# *I-65 TO US-31W CONNECTOR WARREN COUNTY, KENTUCKY*

Item Number 3-16.00  
VE Study Number 201108

Kentucky Transportation Cabinet  
Frankfort, Kentucky

**Final Report**

VALUE ENGINEERING RECOMMENDATION # VE-5

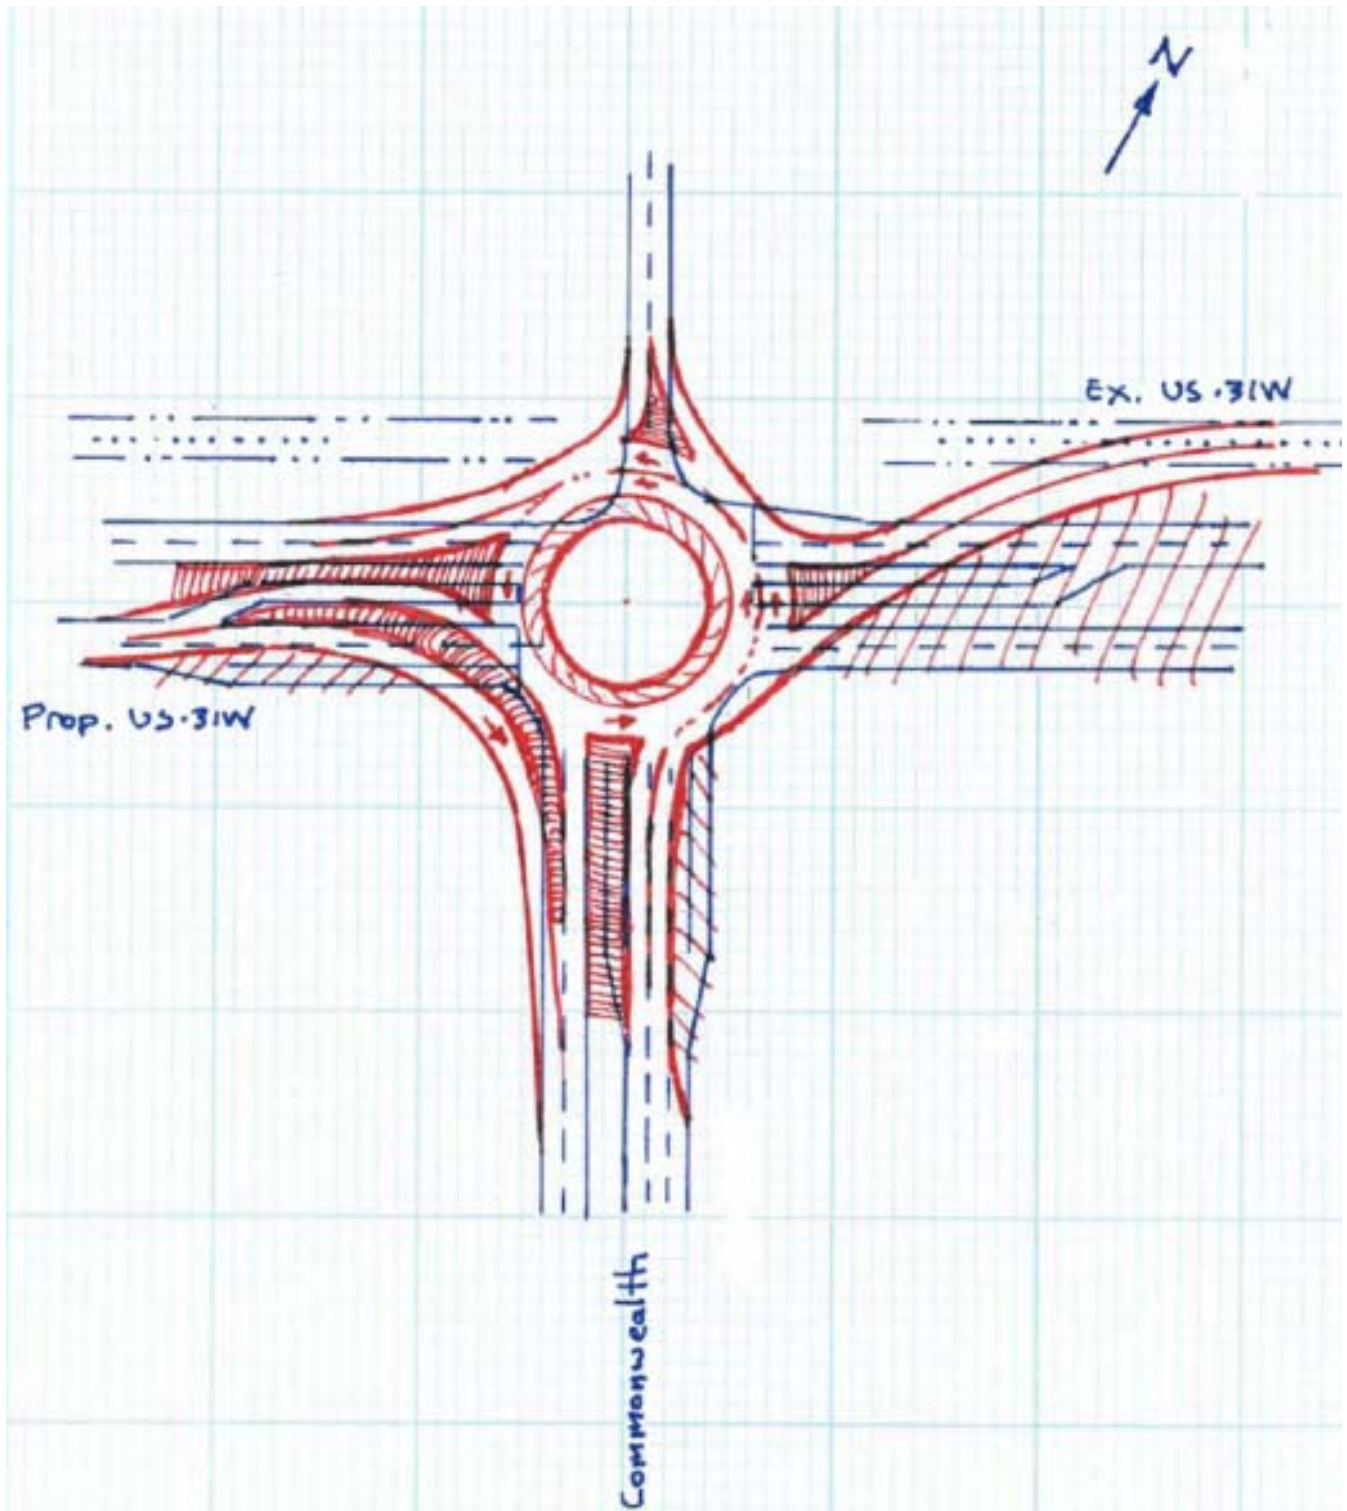
End the widening and reconstruction of US-31W at Commonwealth Boulevard.

The VE Team recommends ending the widening of US-31W at Commonwealth Boulevard and then tying into the existing two lane road east of Commonwealth Boulevard. The VE Team also recommends the construction of a roundabout at Commonwealth Boulevard.

Transition from 4 lane widened section to 2 lanes existing alignment at Commonwealth Boulevard

VALUE ENGINEERING RECOMMENDATION # VE-6

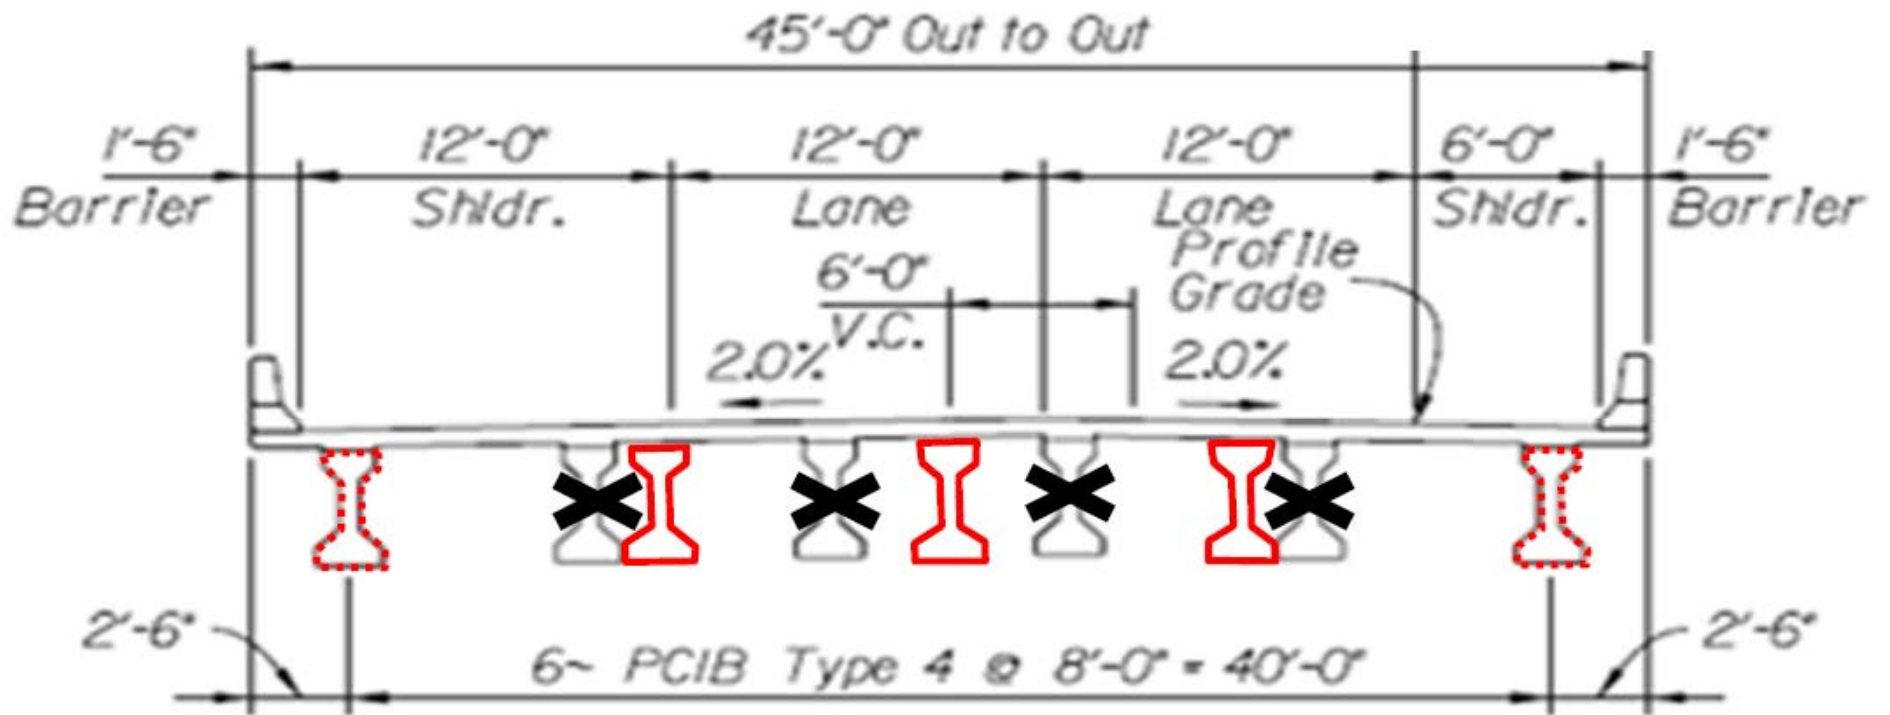
Increase beam spacing to eliminate beam lines, where applicable.

The VE Team recommends increasing beam spacing to eliminate beam lines where possible. The VE Team believes this is a practical alternate at all locations with the exception of the Kelly Road overpass. Reduction in beam lines at this structure would result in a superstructure supported by 3-beam lines which is not recommended. For the Connector Road over US68/KY80, the Connector Road over future Commonwealth Boulevard, and for the Connector Road over I-65 twin bridges, implementation of this policy would result in the reduction of one beam line per bridge.

Utilizing fewer beam lines minimizes structure cost and superstructure dead load. An increase in girder depth may be required, but that extra depth can be accommodated as most of the structures have excess vertical clearance at their current elevations. The minimum deck thickness required by KYTC is 8". It is likely this deck can be designed to accommodate LRFD design loads.

# VALUE ENGINEERING RECOMMENDATION # VE-7

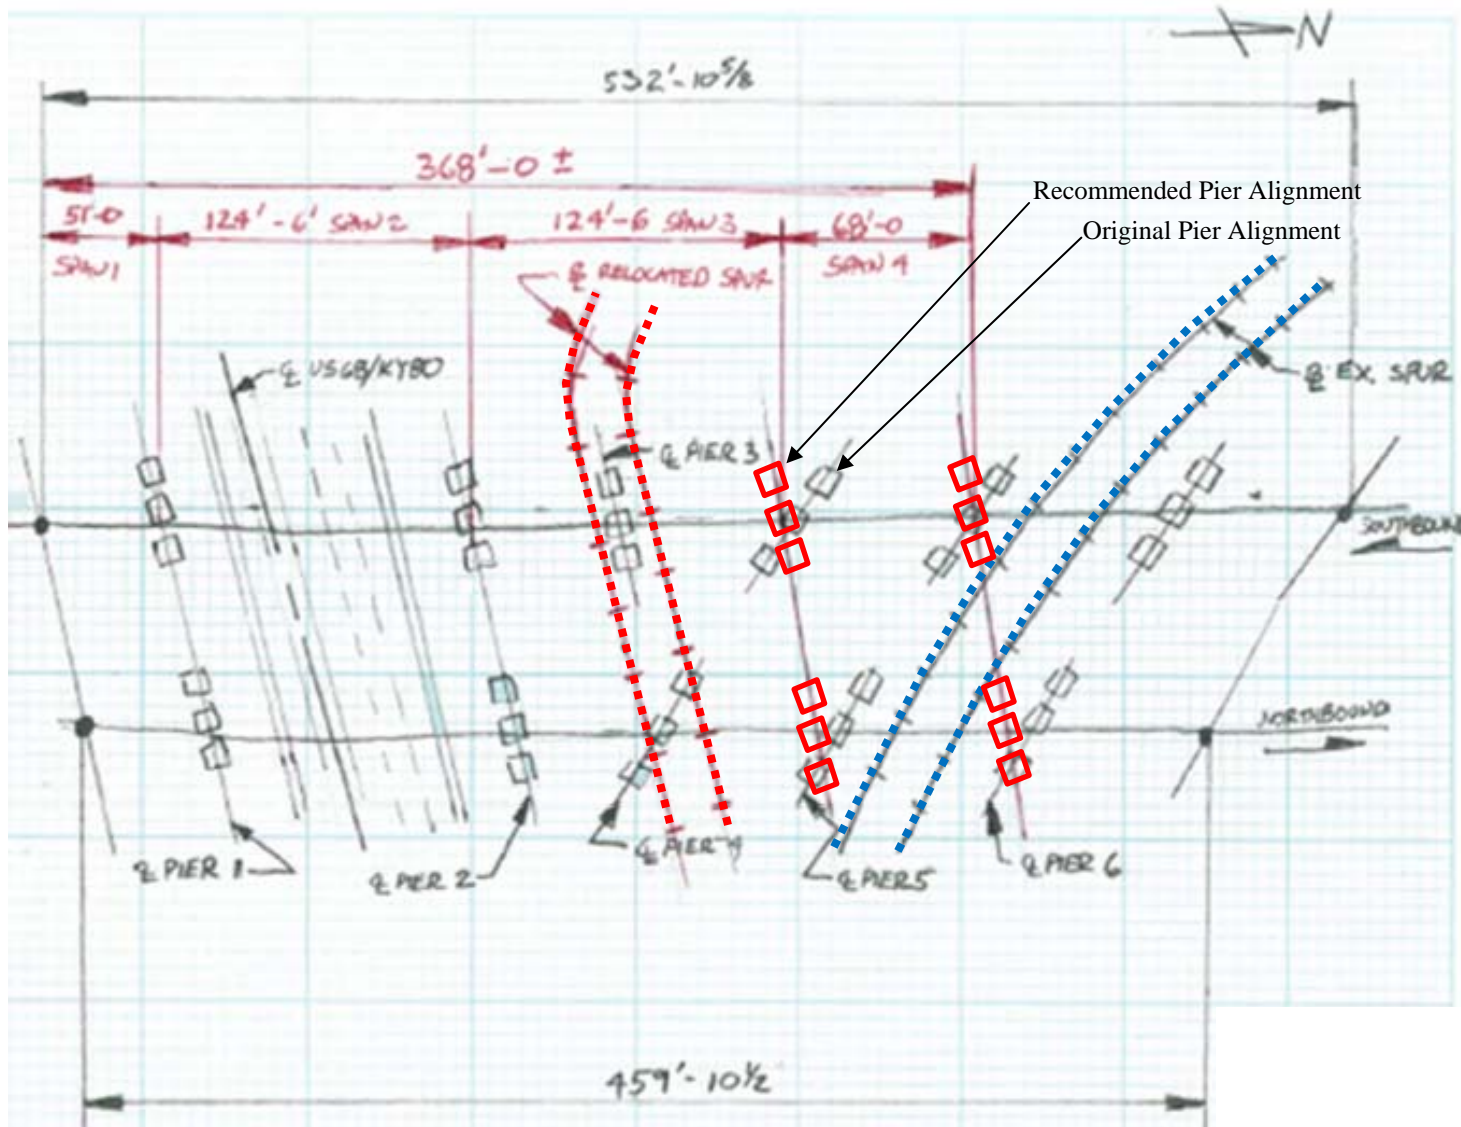
Move the radius of the railroad spur westward to reduce the bridge square footage and variable skew.

The VE Team recommends moving the radius of the railroad spur outside of the bridge limits. Moving the radius as suggested would result in parallel alignments of US68/KY80 and the railroad under the bridge. The change would result in a four span bridge minimizing bridge length. The change would also result in the northbound and southbound structures being similar, and eliminate the widely varying skews on the existing layout. Finally the change would remove the use of different beam sizes on the same structure, the stepped pier seat, and the deck joint that may be a result of the different beam sizes.

Moving the railroad spur radius outside the bridge limits has multiple benefits. A large reduction of total bridge results from shifting the radius. It also eliminates the variable beam depths within the bridge limits. This eliminates the stepped beam seats. It also would eliminate the joint above the beam step, removing the maintenance required at bridge deck joints. The current layout has variable length beams within the same span, resulting in poor manufacturing economy. The widely varying skews result in acute corners at the deck joint. These corners can cause in-use performance problems and often require extra detail and design effort.

**Typical Overpasses Depicting Original 2:1 Slope Design**

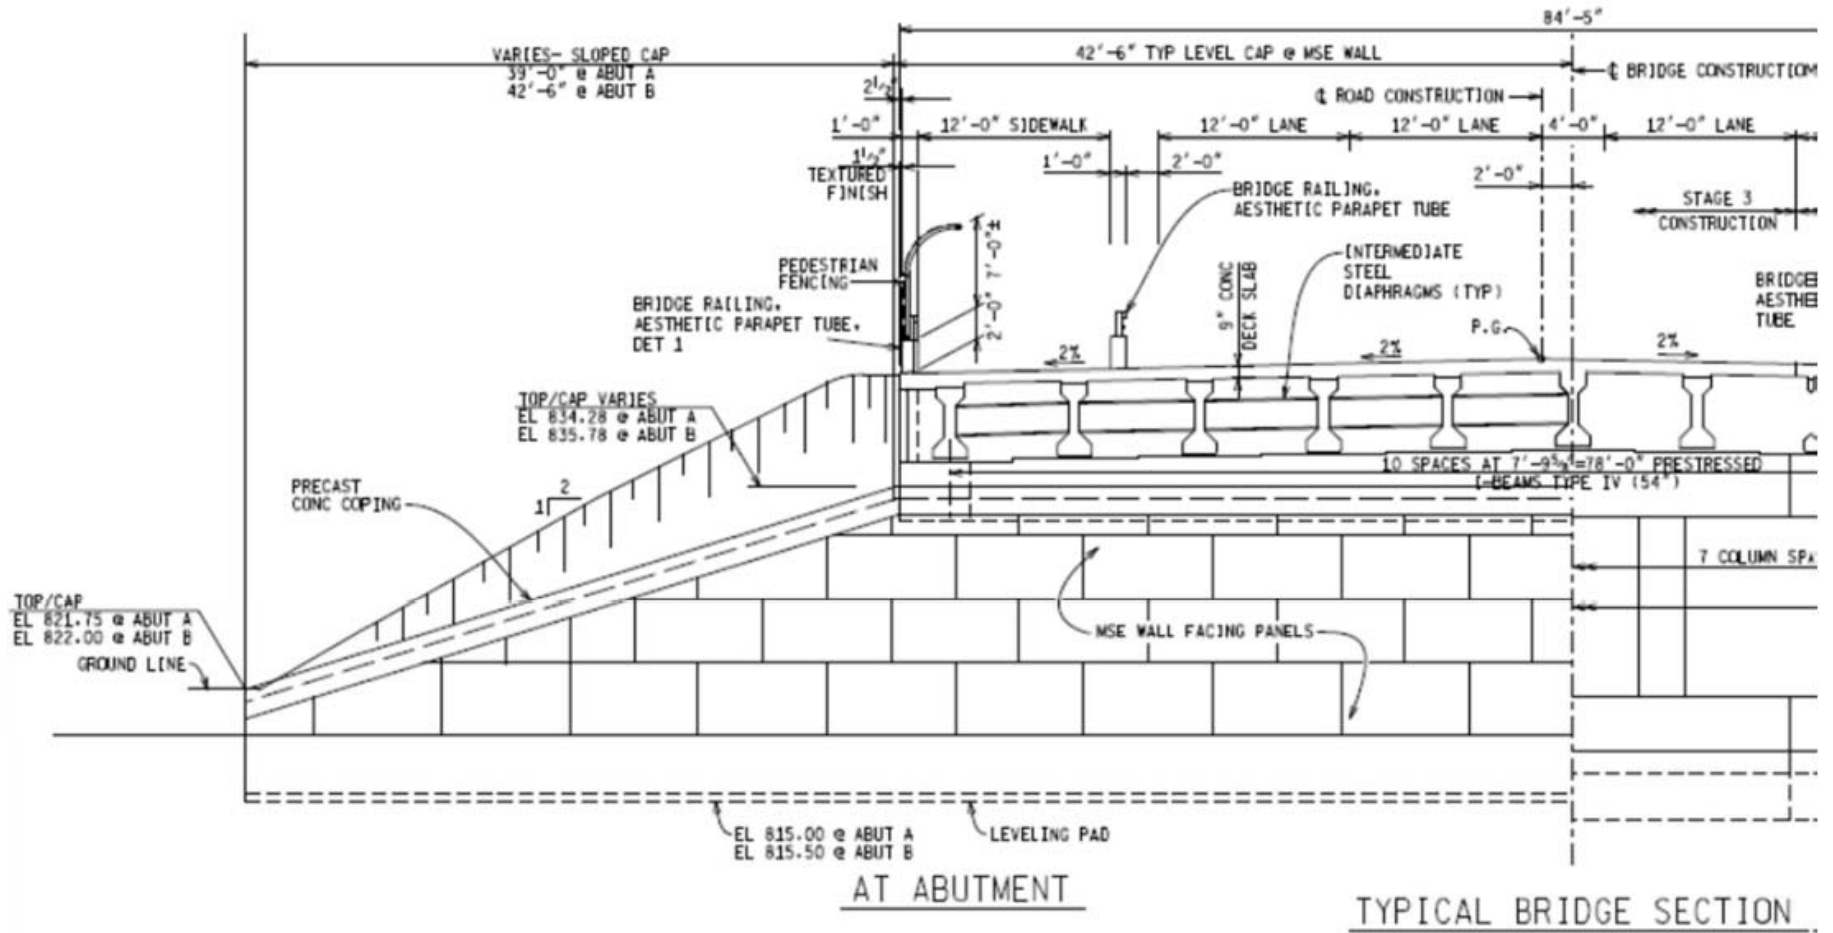
The VE Team recommends MSE walls at the location of the piers and/or bottom of slopes with integral, semi-integral, or end-bent abutments behind the MSE walls. This change will replace bridge deck area with pavement, eliminate slope paving, and replace embankment comprising the spill through slope with an estimated equal amount of road embankment behind the MSE wall, and add MSE wall with soil reinforcement and backfill. The abutments are assumed to remain similar in regards to foundation pile and concrete quantities when comparing the original design and recommended design.

Integral Abutments, MSE Walls, and Single Span at Future Commonwealth Boulevard

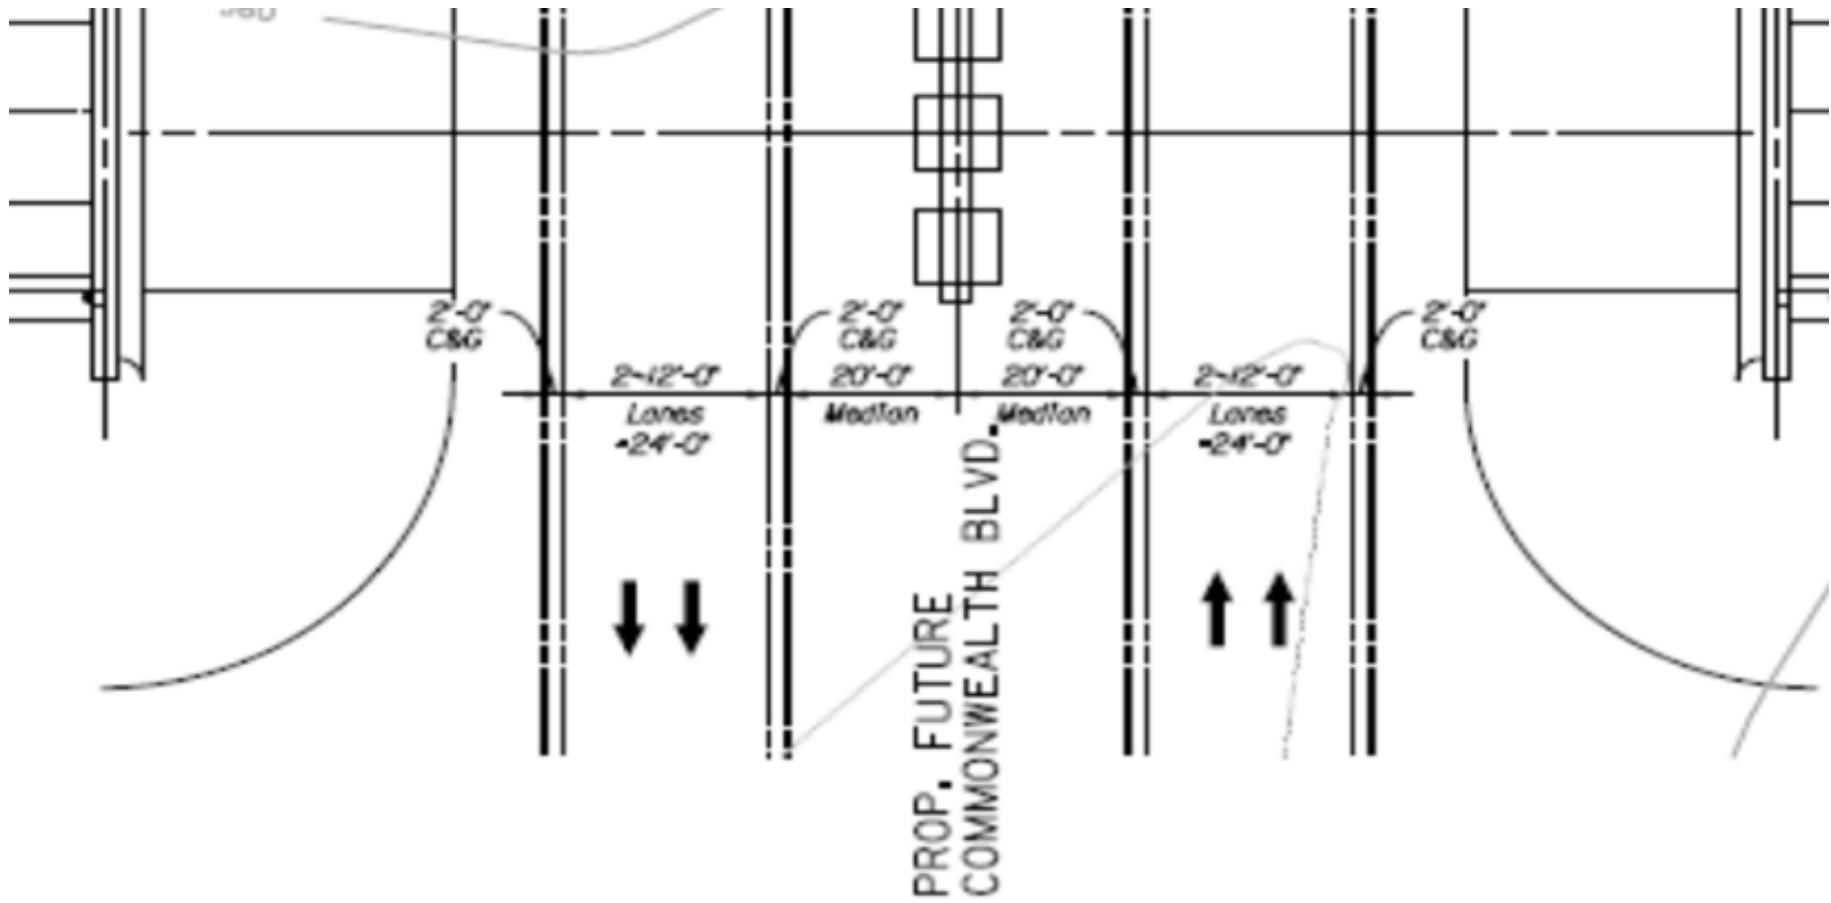
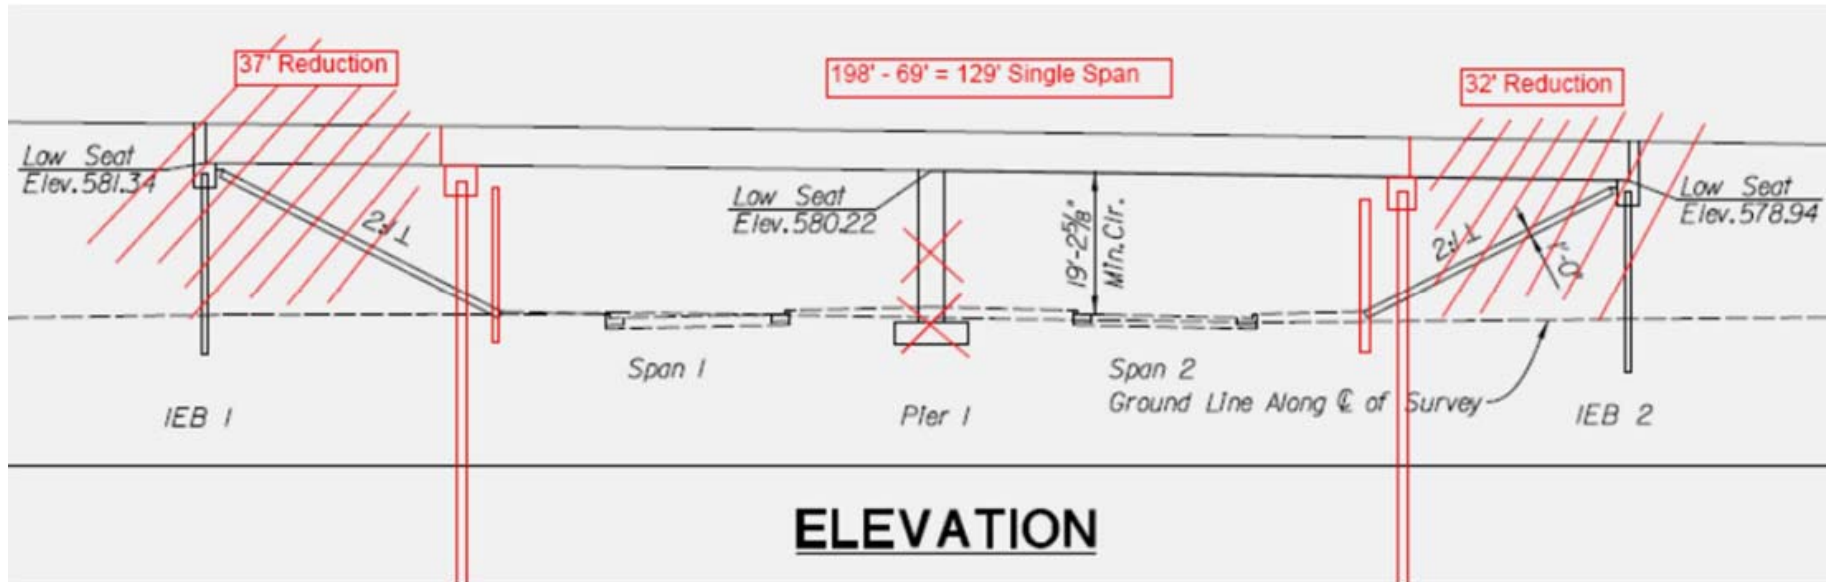
The original design specifies a two-span structure over Commonwealth Boulevard, with a pier in the median and 2:1 spill through slopes from approximate road elevation to the end-bent abutments. The bridge deck area reductions caused by this change are not from abutment to pier because the remaining span lengths over the road needs to increase by six feet to account for the distance from MSE wall face to the proposed integral, semi-integral, or end-bent abutment behind it. The following shows the area of tail span at each of these bridges, minus the six feet just discussed.

The VE Team recommends a single span structure because excess underclearance allows for deeper beams. As part of this change, MSE walls are added at the bottom of slopes with integral, semi-integral, or end-bent abutments behind the MSE walls. This change will reduce a two span bridge to a single span, replace bridge deck area with pavement, eliminate slope paving, and replace embankment comprising the spill through slope with an estimated equal amount of road embankment behind the MSE wall, and add MSE wall with soil reinforcement and backfill. The abutments are assumed to remain similar in regards to foundation pile and concrete quantities when comparing the original design and recommended design.

The primary purpose of this recommended change is to reduce bridge deck area. One of the primary drivers that make this change possible is that the railroad spur drives the vertical grade up just to the south of Commonwealth Boulevard. This increases in the vertical grade of the connector to provide excess underclearance at Commonwealth Boulevard. Therefore the bridge beam depth can increase and longer spans are feasible.
